AGENDA
BOARD OF ZONING APPEALS
 Tuesday, May 17, 2016 – 5:00 PM
City Council Chambers
 125 East Avenue B, Hutchinson, Kansas

Case: 16-BZA-02

Project:	Erickson Bar/Tavern Request	DRC Meeting Date:	3/22/16; 4/26/16
Address:	1221 E 4 th Ave Hutchinson KS 67501	BZA Meeting Date:	4/19/16- tabled to 5/17/16 Meeting
Case #:	16-SUP-03; 16-BZA-02	Planner:	Jana McCarron

Project:	Erickson Bar/Tavern Request	DRC Meeting Date:	3/22/16; 4/26/16
Address:	1321 E 4 th Ave Hutchinson KS 67501	BZA Meeting Date:	4/19/16- tabled to 5/17/16 Meeting
Case #:	16-SUP-04; 16-BZA-03	Planner:	Jana McCarron

SITE PLAN/SURVEY:

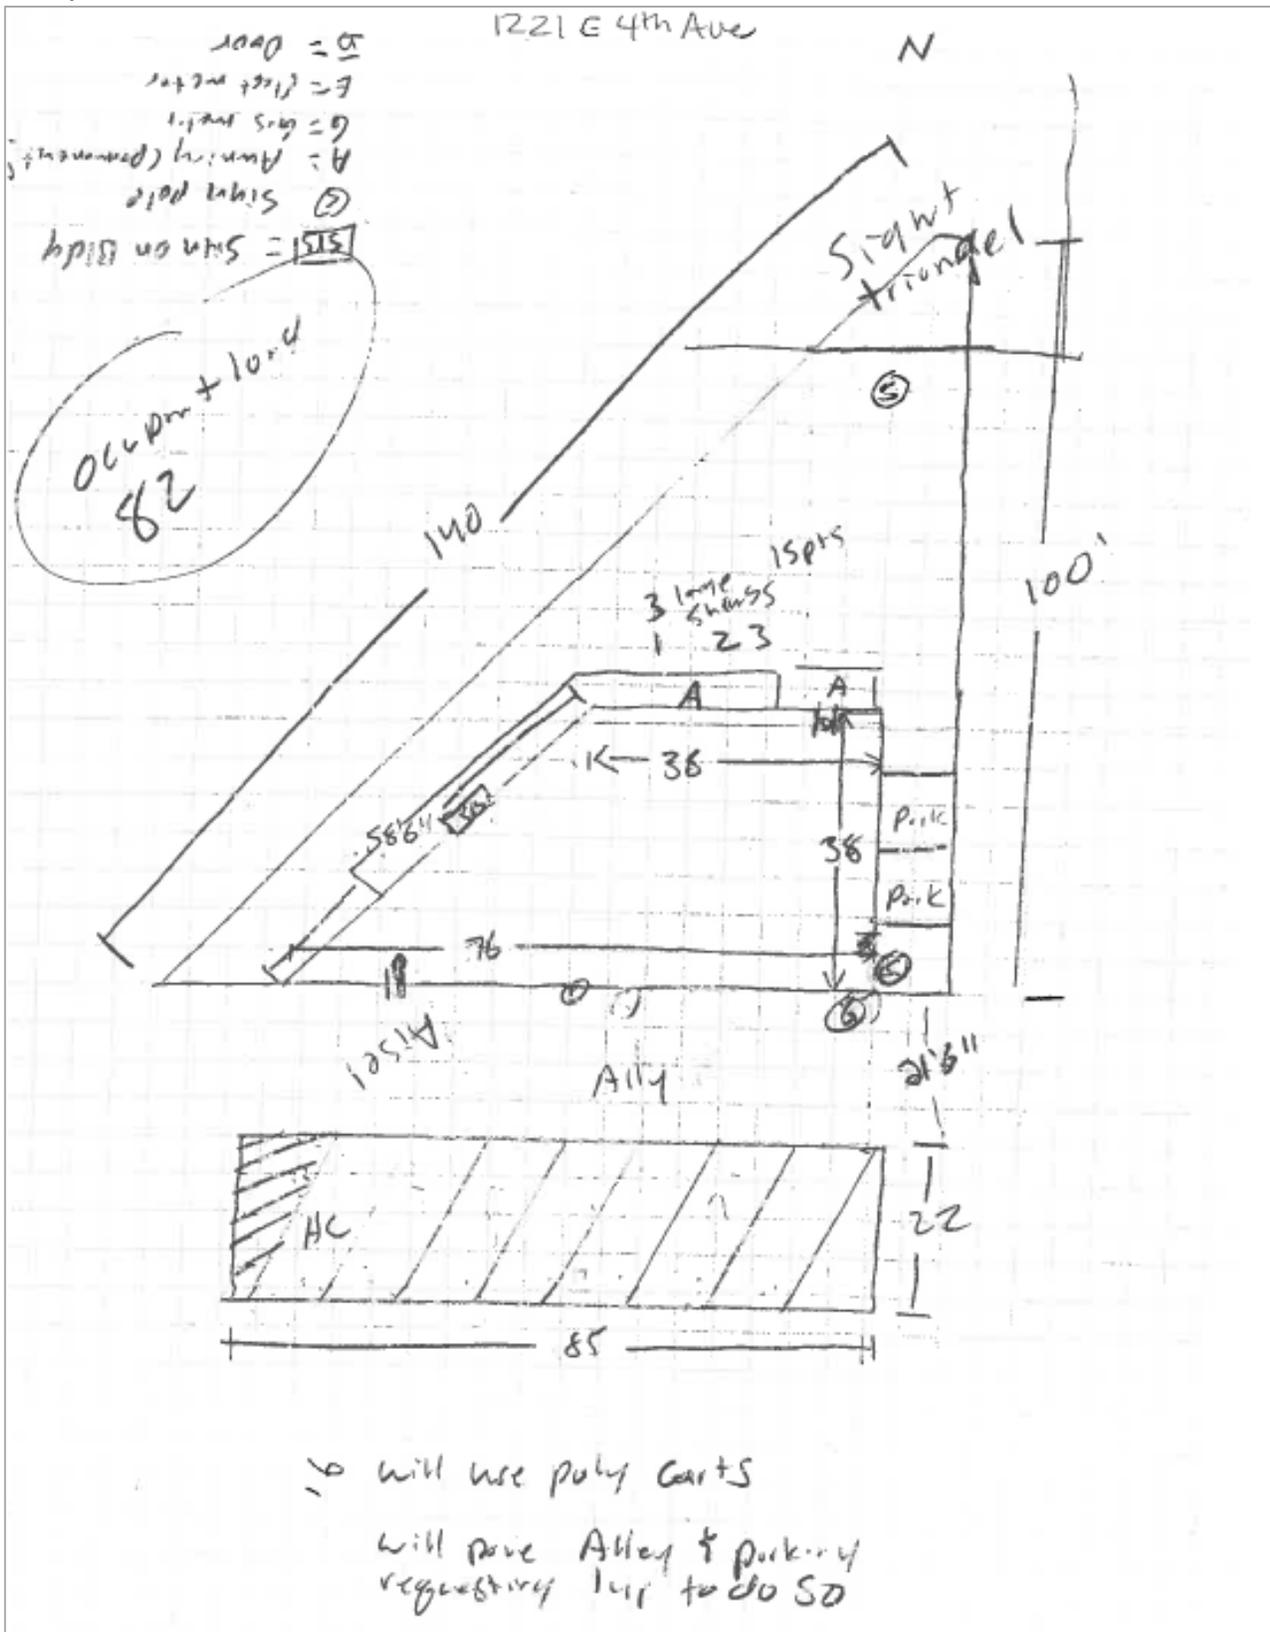
Planning staff and the Development Review Committee have reviewed the revised site plan received on April 14, 2016, for the above-referenced project. Comments are as follows:

See Development Review Committee comments dated 3/22/2016. Variance requests have been made for parking and loading.

Submitted plan does not meet the minimum requirements of the *Hutchinson Zoning Regulations*, as follows. Approval of the Special Use Permit is contingent upon obtaining the necessary variances and extensions, as noted below.

Item	Standard	Provided	Determination
Parking Space, Driveway & Drive Aisles (§27-701.D & §27-701.O)	Parking spaces measuring 9'x18' (9'x23' parallel) are required to be delineated, as are driveways and drive aisles.	9'x18'; driveways are delineated and meet standards. Parking is located on an adjacent lot to the south side of the alley.	<input checked="" type="checkbox"/> Met <input type="checkbox"/> Not Met
Required Parking (§27-702)	One space per each 4 occupants. Occupant load is 82; 21 spaces are required.	7 off-street and 2 on-street spaces are provided [see 16-BZA-02]	<input type="checkbox"/> Met <input checked="" type="checkbox"/> Not Met
Timing of Paving	Parking spaces, drive aisles, driveways and loading areas are required to be paved with asphalt or concrete prior to issuance of the occupancy permit for the proposed use.	Applicant has requested 12 months from the date of occupancy permit to add alley paving with asphalt or concrete, which would be used as the drive aisle for the adjacent parking to the south.	<input type="checkbox"/> Met <input checked="" type="checkbox"/> Not Met

Van Accessible Parking	One van accessible space 8' wide with an 8' access area is required.	Space provided is slightly smaller than 16' total. Staff will make this a condition of approval.	<input type="checkbox"/> Met <input checked="" type="checkbox"/> Not Met
Trash Enclosure	Screened trash enclosure is required unless polycarts will be used.	Applicant has noted polycarts will be used	<input checked="" type="checkbox"/> Met <input type="checkbox"/> Not Met
Signage (§27-801)	All signs shall meet the requirements of the <i>Hutchinson Zoning Regulations</i> and a sign permit shall be obtained prior to installation.	Existing sign location is shown	<input checked="" type="checkbox"/> Met <input type="checkbox"/> Not Met
Loading (§27-701.H.)	One loading space 35 feet long, 12 feet wide, with 14 foot of vertical clearance is required.	Applicant has requested a variance from this requirement. [16-BZA-02].	<input type="checkbox"/> Met <input checked="" type="checkbox"/> Not Met

Item	Standard	Provided	Determination
Landscaping (§27-908)	Staff estimates 11 points (disturbed area) are needed. Turf can count toward 3 points of total landscaping.	Site plan includes a note stating there will be 3 large additional shrubs for a total of 15 points. The minimum sizes and timing of installation should be made conditions of approval of the permit.	<input checked="" type="checkbox"/> Met <input checked="" type="checkbox"/> Not Met
Exterior Lighting (§27-909)	Exterior lighting shall meet the requirements of the <i>Hutchinson Zoning Regulations</i> .		<input checked="" type="checkbox"/> Met <input type="checkbox"/> Not Met
Bicycle Parking	1 bicycle parking space is recommended.	No spaces are shown, but this is not required.	<input checked="" type="checkbox"/> Met <input type="checkbox"/> Not Met
Mechanical Equipment Screening (§27-908.E.8)	Mechanical equipment, including transformer pads, must be screened.	It appears this item is met.	<input checked="" type="checkbox"/> Met <input type="checkbox"/> Not Met

Alley Access	Any use of the ally for access to the adjacent property for parking shall require paving of the alley to City specifications.	Applicant has requested an extension for a period of one year from the date of Occupancy to comply with this requirement. Engineering Department: Provide engineering drawings for proposed alley paving for review and approval.	<input type="checkbox"/> Met <input checked="" type="checkbox"/> Not Met
Curb Guards	Curb guards required for parking areas that abut the property line.	None shown. Staff will make this a condition of approval.	<input type="checkbox"/> Met <input checked="" type="checkbox"/> Not Met

SITE PLAN/SURVEY:

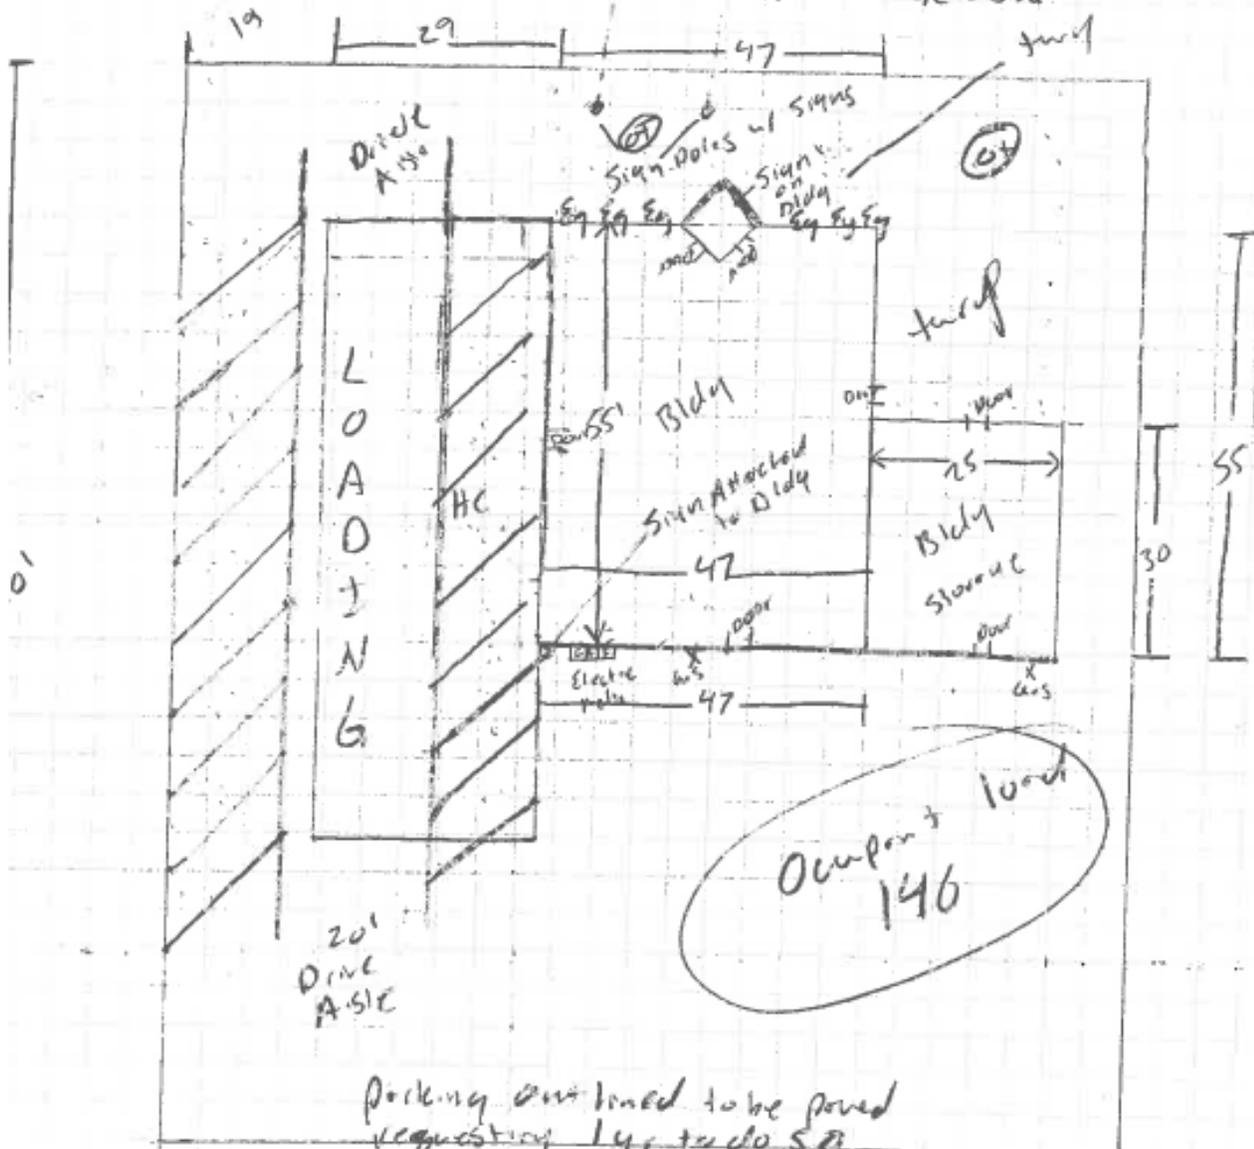
Planning staff and the Development Review Committee have reviewed the revised site plan received on April 14, 2016, for the above-referenced project. Comments are as follows:

See Development Review Committee comments dated 3/22/2016. Loading comment has been addressed. Variance requests have been made for parking and landscaping.

Submitted plan does not meet the minimum requirements of the *Hutchinson Zoning Regulations*, as follows. Approval of the Special Use Permit is contingent upon obtaining the necessary variances and extensions, as noted below.

Item	Standard	Provided	Determination
Parking Space, Driveway & Drive Aisles (§27-701.D & §27-701.O)	Parking spaces measuring 9'x18' (9'x23' parallel) are required to be delineated, as are driveways and drive aisles.	9'x18'; driveways are delineated and meet standards	<input checked="" type="checkbox"/> Met <input type="checkbox"/> Not Met
Required Parking (§27-702)	One space per each 4 occupants. Occupant load is 146; 37 spaces are required.	15 spaces are provided [see 16-BZA-03]	<input type="checkbox"/> Met <input checked="" type="checkbox"/> Not Met
Timing of Paving	Parking spaces, drive aisles, driveways and loading areas are required to be paved with asphalt or concrete prior to issuance of the occupancy permit for the proposed use.	Applicant has requested 12 months from the date of occupancy permit to install asphalt or concrete paving. All drive aisles, driveways and parking areas shall be paved with asphalt or concrete.	<input type="checkbox"/> Met <input checked="" type="checkbox"/> Not Met

Van Accessible Parking	One van accessible space 8' wide with an 8' access area is required.	Space provided is slightly smaller than 16' total. Staff will make this a condition of approval.	<input type="checkbox"/> Met <input checked="" type="checkbox"/> Not Met
Trash Enclosure	Screened trash enclosure is required unless polycarts will be used.	Applicant has noted polycarts will be used	<input checked="" type="checkbox"/> Met <input type="checkbox"/> Not Met
Signage (§27-801)	All signs shall meet the requirements of the <i>Hutchinson Zoning Regulations</i> and a sign permit shall be obtained prior to installation.	Existing sign locations are shown	<input checked="" type="checkbox"/> Met <input type="checkbox"/> Not Met
Loading (§27-701.H.)	One loading space 35 feet long, 12 feet wide, with 14 foot of vertical clearance is required.	Loading space is shown	<input checked="" type="checkbox"/> Met <input type="checkbox"/> Not Met

Item	Standard	Provided	Determination
Landscaping (§27-908)	Staff estimates 52 points (disturbed area) plus 30 points (parking) are needed. All parking lot spaces are required to be no more than 75 feet from an intervening landscaped area.	Site plan contains 6 evergreen trees and 2 ornamental trees. Small evergreen trees 5-6 feet in height are 9 points each. Ornamental trees 5-6 feet in height are 9 points each. This totals 72 points. The property also contains existing turf area which will likely add up to the remaining 10 points. The minimum sizes and timing of installation should be made conditions of approval of the permit. No landscaping has been included in the parking lot areas. [16-BZA-03]	<input checked="" type="checkbox"/> Met <input checked="" type="checkbox"/> Not Met
Exterior Lighting (§27-909)	Exterior lighting shall meet the requirements of the <i>Hutchinson Zoning Regulations</i> .		<input checked="" type="checkbox"/> Met <input type="checkbox"/> Not Met

Bicycle Parking	1 bicycle parking space is recommended.	No spaces are shown, but this is not required.	<input checked="" type="checkbox"/> Met <input type="checkbox"/> Not Met
Mechanical Equipment Screening (§27-908.E.8)	Mechanical equipment, including transformer pads, must be screened.	It appears this item is met.	<input checked="" type="checkbox"/> Met <input type="checkbox"/> Not Met
Alley Access	Alley access requires paving.	The applicant is not proposing alley access and the alley shall not be used for circulation unless it is paved to the standards of the City Engineer.	<input checked="" type="checkbox"/> Met <input type="checkbox"/> Not Met
Curb Guards	Curb guards are required for parking areas the abut the property line.	None shown. Staff will recommend curb guards be a condition of approval.	<input type="checkbox"/> Met <input checked="" type="checkbox"/> Not Met
End Bay Width	Minimum end bay width without an overhang is 19'.	End bay width appears to be 15', though space length is 21'. Without a survey, it is difficult to determine if the applicant has sufficient room for the proposed parking layout. <u>A certified survey along with parking diagram shall be provided prior to installation of the required additional parking. If the 8 spaces shown on the western side of the lot cannot meet the City's standards, parking will be required to be located south of the building.</u>	<input type="checkbox"/> Met <input checked="" type="checkbox"/> Not Met

SITE PLAN/SURVEY:

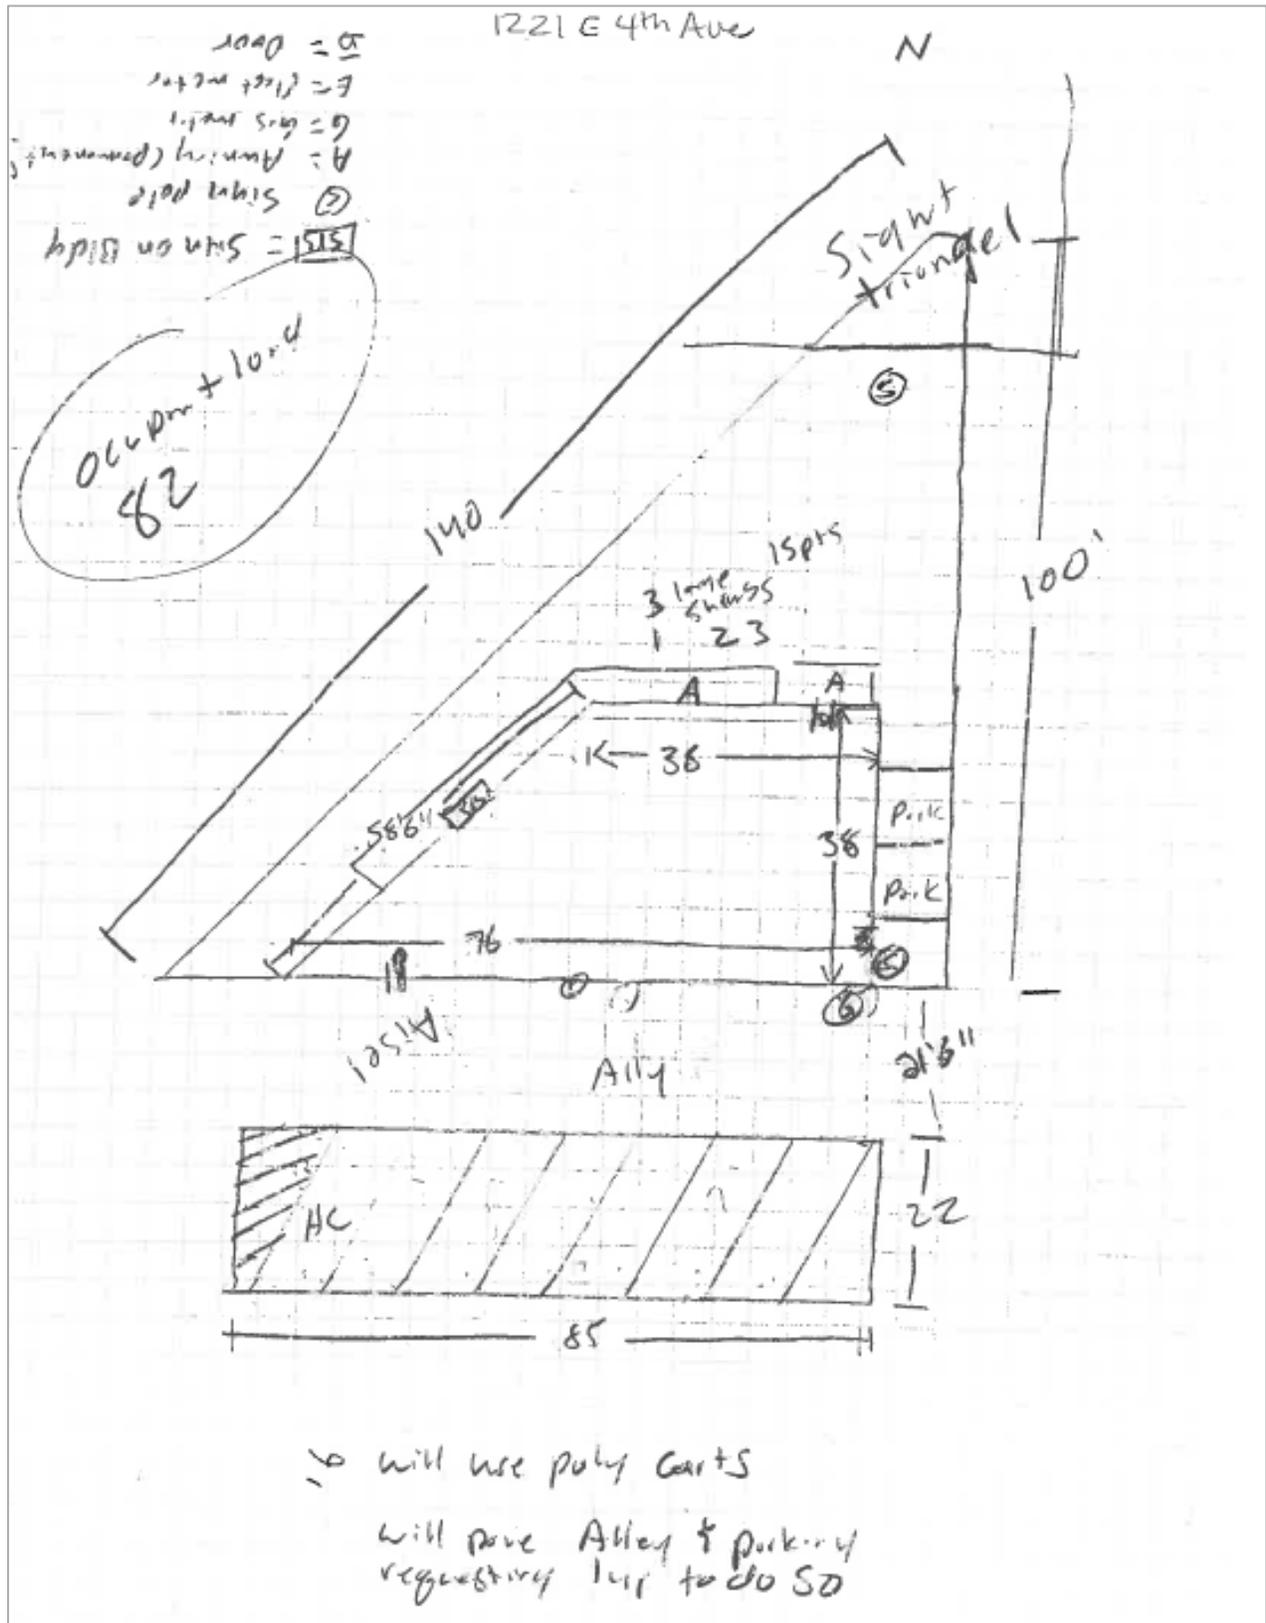
Planning staff and the Development Review Committee have reviewed the revised site plan received on April 14, 2016, for the above-referenced project. Comments are as follows:

See Development Review Committee comments dated 3/22/2016. Variance requests have been made for parking and loading.

Submitted plan does not meet the minimum requirements of the *Hutchinson Zoning Regulations*, as follows. Approval of the Special Use Permit is contingent upon obtaining the necessary variances and extensions, as noted below.

Item	Standard	Provided	Determination
Parking Space, Driveway & Drive Aisles (§27-701.D & §27-701.O)	Parking spaces measuring 9'x18' (9'x23' parallel) are required to be delineated, as are driveways and drive aisles.	9'x18'; driveways are delineated and meet standards. Parking is located on an adjacent lot to the south side of the alley.	<input checked="" type="checkbox"/> Met <input type="checkbox"/> Not Met
Required Parking (§27-702)	One space per each 4 occupants. Occupant load is 82; 21 spaces are required.	7 off-street and 2 on-street spaces are provided [see 16-BZA-02]	<input type="checkbox"/> Met <input checked="" type="checkbox"/> Not Met
Timing of Paving	Parking spaces, drive aisles, driveways and loading areas are required to be paved with asphalt or concrete prior to issuance of the occupancy permit for the proposed use.	Applicant has requested 12 months from the date of occupancy permit to add alley paving with asphalt or concrete, which would be used as the drive aisle for the adjacent parking to the south.	<input type="checkbox"/> Met <input checked="" type="checkbox"/> Not Met

Van Accessible Parking	One van accessible space 8' wide with an 8' access area is required.	Space provided is slightly smaller than 16' total. Staff will make this a condition of approval.	<input type="checkbox"/> Met <input checked="" type="checkbox"/> Not Met
Trash Enclosure	Screened trash enclosure is required unless polycarts will be used.	Applicant has noted polycarts will be used	<input checked="" type="checkbox"/> Met <input type="checkbox"/> Not Met
Signage (§27-801)	All signs shall meet the requirements of the <i>Hutchinson Zoning Regulations</i> and a sign permit shall be obtained prior to installation.	Existing sign location is shown	<input checked="" type="checkbox"/> Met <input type="checkbox"/> Not Met
Loading (§27-701.H.)	One loading space 35 feet long, 12 feet wide, with 14 foot of vertical clearance is required.	Applicant has requested a variance from this requirement. [16-BZA-02].	<input type="checkbox"/> Met <input checked="" type="checkbox"/> Not Met

Item	Standard	Provided	Determination
Landscaping (§27-908)	Staff estimates 11 points (disturbed area) are needed. Turf can count toward 3 points of total landscaping.	Site plan includes a note stating there will be 3 large additional shrubs for a total of 15 points. The minimum sizes and timing of installation should be made conditions of approval of the permit.	<input checked="" type="checkbox"/> Met <input checked="" type="checkbox"/> Not Met
Exterior Lighting (§27-909)	Exterior lighting shall meet the requirements of the <i>Hutchinson Zoning Regulations</i> .		<input checked="" type="checkbox"/> Met <input type="checkbox"/> Not Met
Bicycle Parking	1 bicycle parking space is recommended.	No spaces are shown, but this is not required.	<input checked="" type="checkbox"/> Met <input type="checkbox"/> Not Met
Mechanical Equipment Screening (§27-908.E.8)	Mechanical equipment, including transformer pads, must be screened.	It appears this item is met.	<input checked="" type="checkbox"/> Met <input type="checkbox"/> Not Met

Alley Access	Any use of the ally for access to the adjacent property for parking shall require paving of the alley to City specifications.	Applicant has requested an extension for a period of one year from the date of Occupancy to comply with this requirement. Engineering Department: Provide engineering drawings for proposed alley paving for review and approval.	<input type="checkbox"/> Met <input checked="" type="checkbox"/> Not Met
Curb Guards	Curb guards required for parking areas that abut the property line.	None shown. Staff will make this a condition of approval.	<input type="checkbox"/> Met <input checked="" type="checkbox"/> Not Met

Planning staff and the Development Review Committee have reviewed the site plan received on March 10, 2016, for the above-referenced project and have the following comments:

- **Parking.** There is no provision for off-street parking. The two spaces annotated on the site plan appear to be located in the City of Hutchinson right-of-way. (§27-701.D & §27-702)

- **Landscaping.** Landscaping does not appear to meet the minimum standards of the zoning regulations. A landscaping plan is required as noted on the Special Use Permit Application form, but none was submitted. (Absent a landscape spreadsheet, staff cannot make a final determination on this nonconformity.) (§27-908, et seq.)

- **Loading.** The lot does not contain an approved loading space. (§27-701.H)
 - **Driveways.** The existing driveway approaches lead to an unimproved area on the north side of the building. Unimproved driveways and parking areas are not permitted. All required parking areas and drive aisles associated with existing and new uses on the property shall be paved. (§27-701.D)

a. Section 27-502.B. contains the application procedure and submittal requirements for special use permits. The sketch plan provided with the application is insufficient and cannot be approved by the Board of Zoning Appeals, as the following items are missing or are inaccurate from the drawing:

- Parking area is shown but spaces are not delineated
- Dimensions of structure are not shown
- Landscaping is not shown
- Parcel boundaries are not shown
- Existing, abandoned sign is not shown

- b. **Existing driveway.** The site plan shows an existing driveway that goes to an unpaved parking area. This area cannot be used for parking unless it is paved with either asphalt or concrete. Revise the plans to show the planned paving material or remove both driveway approaches. One additional parking space could be gained in this area.

- c. **Parking/driving areas.** All parking and driving areas shall be paved with asphalt or concrete. Label the materials on the plans.
- d. **Disabled Parking Space.** One, paved van accessible disabled parking space is needed. The space is required to be a minimum of 18' long and 8' wide with an 8' accessible aisle (parallel parking spaces need to be 23' long). Staff recommends this be placed in the area adjacent to the building that already has drive access (it will just need to be paved). Revised plans are needed.

- e. **Trash Enclosure.** No trash bin is shown. If a dumpster will be used, this must be screened unless placed along the alley. If polycarts are used, no screening is required. Show dumpster and/or polycart location on the plans and screening, if needed.

- f. **Signage.** All signs shall meet the requirements of the *Hutchinson Zoning Regulations* (see §27-801) and a sign permit shall be obtained prior to installation. An existing sign is located on the property. Show the sign on the plans and indicate whether this sign is to remain.

- g. **Sight Triangle.** No objects, including parked vehicles, taller than 30" or shorter than 10' feet shall be allowed within the Sight Triangle area. Show the Sight Triangle on the plans and ensure this area is protected. See §27-308 of the *Hutchinson Zoning Regulations* for required sight triangle dimensions.

- i. **Landscaping.** The City of Hutchinson's landscaping requirements are contained in §27-908. No landscaping plans were provided, However, they are required. Staff estimates the developed area of the property is 2,190 square feet, which equates to 11 points of landscaping required. The existing turf can count toward a maximum of 25% of the required points (or 3 points). An additional 8 points are needed. The City's landscaping spreadsheet is attached for your use. Please show landscaping on revised plans and submit the landscape spreadsheet.

1. This special use permit shall only be used for a bar/tavern in the existing structure located at 1221 E 4th Avenue;
2. An additional seven off-site parking stalls shall be installed and paved with asphalt or concrete in accordance with the approved site plan within one year of the date of approval of the special use permit;
3. The alley shall be paved with concrete and in accordance with plans submitted to and approved by the City Engineer. Paving of the alley shall be performed within one year of the date of approval of the special use permit;
4. Loading and stocking shall be from the existing alley; and
5. Landscaping shall be installed in accordance with the approved site plan prior to issuance of the final occupancy permit for the use.
